# Technical Service Bulletin

<b>SUBJECT:</b> <b>DTCs P0657, P1590, U0101, P0201 – P0206 &amp; POSSIBLE NO START</b>			<b>No:</b> <b>TSB-07-13-010</b>
			<b>DATE:</b> <b>December, 2007</b>
			<b>MODEL:</b> <b>See Below</b>
<b>CIRCULATE TO:</b>	<input type="checkbox"/> GENERAL MANAGER	<input checked="" type="checkbox"/> PARTS MANAGER	<input checked="" type="checkbox"/> TECHNICIAN
<input checked="" type="checkbox"/> SERVICE ADVISOR	<input checked="" type="checkbox"/> SERVICE MANAGER	<input checked="" type="checkbox"/> WARRANTY PROCESSOR	<input type="checkbox"/> SALES MANAGER

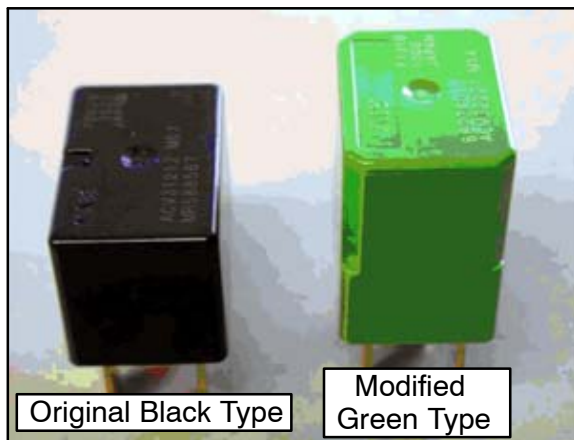
The customer may also complain of a no-start condition, however dealers may find it difficult to recreate. The condition is caused by condensation freezing inside the relay, rendering it inoperative. Should you suspect very cold weather has caused either or both of these conditions in an affected vehicle, follow the procedure below to identify and replace four (4) relays with a modified type.

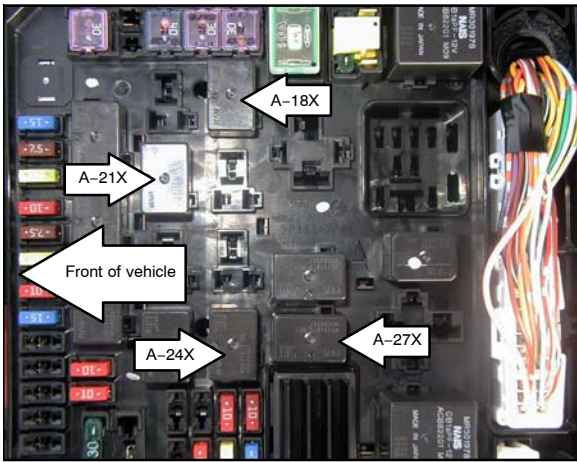
1. Identify which type of relay is fitted in the relay box. If the vehicle is fitted with the "Original Black Type," continue with the following steps. If it is fitted with the "Modified Green Type," diagnose the condition as per the service manual
2. Using the MUT-III, read DTCs and record Freeze Frame Data. Note if the data shows the intake air temperature at approximately -5° F (-20°C) or colder.
3. Erase any DTCs and start the vehicle.
4. Check for provisional DTCs.
5. If no DTCs are reset, perform the following steps to replace the relays.

**NOTE: ONLY INSTALL A NEW RELAY IN LOCATIONS INDICATED IN THE PHOTO.**

6. Replace the following relays with the updated type as described in the Parts Information section of this bulletin.
- A-18X      A/T Control Relay
  - A-21X      Throttle Valve Control Servo Relay
  - A-24X      Injector Relay
  - A-27X      Starter Relay
